AGENDA PLANNING COMMISSION MEETING

April 16, 2026 - 6:00 PM
City Hall Council Chambers

Progressive, LLC is proposing development of 51 dwelling units on 21.3 acres of land located at the southwest corner of Kenwood Avenue (CSAH 50) and Ipava Avenue. The proposed development requires consideration of applications for a Comprehensive Plan amendment guiding the property for a single residential land use category; Zoning Map rezoning portions of the property to RST-2 District; a Conditional Use Permit for Planned Shoreland Development; Preliminary Plat; and Vacation of existing public right-of-way.

SHORELAND TIER DENSITY

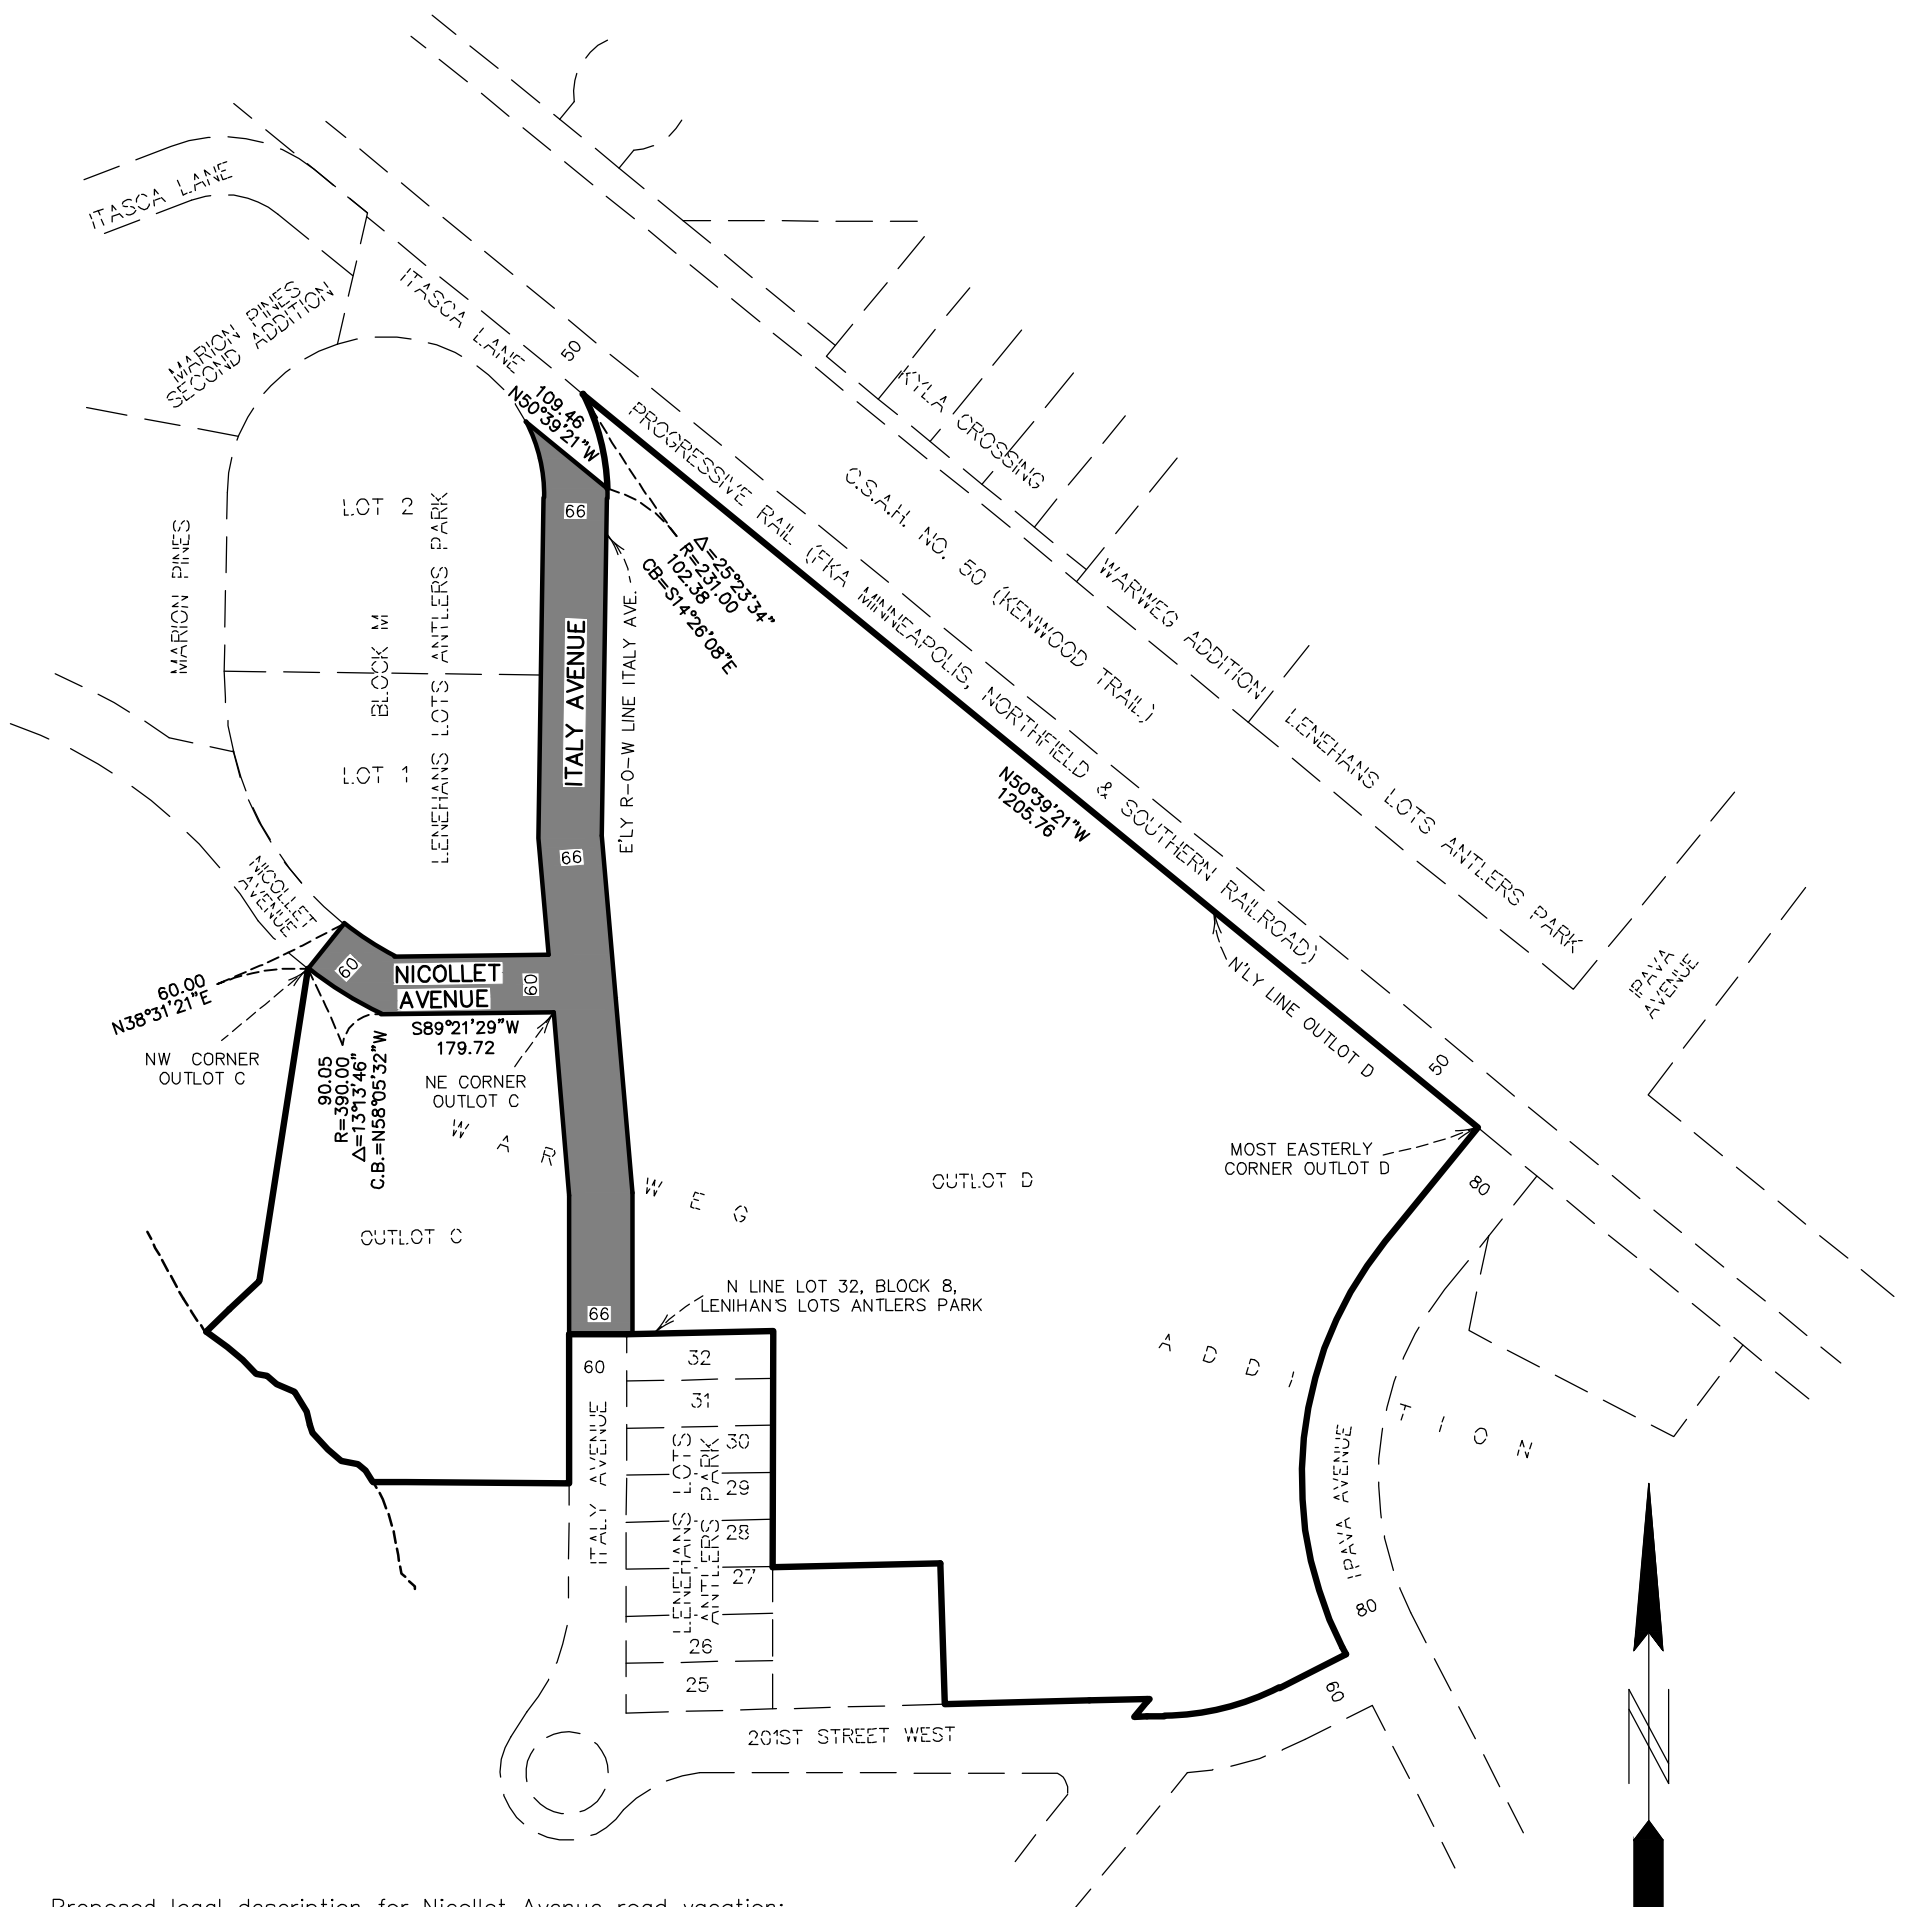
- Section 11-102-21.D of the Zoning Ordinance outlines the methodology for a density tier analysis to determine the maximum number of dwelling units that can be developed within Blocks 1 and 2. Sheet P1 of the submitted plans includes the tiered density calculation required by the Zoning Ordinance and indicates that the number of dwelling units within each tier and the overall number of dwelling units is within the density allowed.
